## **TPS40074 Errata**

- TPS40074

Figure 1. Limiting the Slew Rate

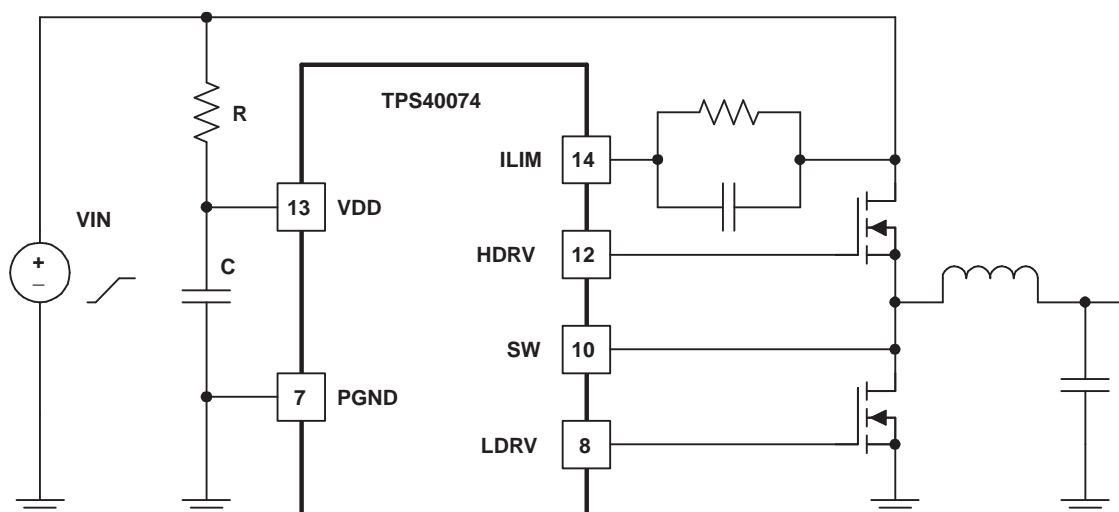
### 2.7 High Slew Rate Input Voltage can cause Overshoot and Damage the Device

- **Cause:** If input rises too quickly the device's internal 10-V regulator can over shoot which will damage the device.
- **Corrective Action:** Add a small RC on the VDD pin of the device. Details can be found in the data sheet.

The regulator that supplies power for the drivers on the TPS40070/1 requires a limited rising slew rate on VDD for proper operation if the input voltage is above 10 V. If the slew rate is too great, this regulator can over shoot and damage to the part can occur. To ensure that the part operates properly, limit the slew rate to no more than 0.12 V/ $\mu$ s as the voltage at VDD crosses 8 V. If necessary, an R-C filter can be used on the VDD pin of the device. Connect the resistor from the VDD pin to the input supply of the converter. Connect the capacitor from the VDD pin to PGND. There should not be excessive (more than a 200-mV) voltage drop across the resistor in normal operation. This places some constraints on the R-C values that can be used. is a schematic fragment that shows the connection of the R-C slew rate limit circuit.
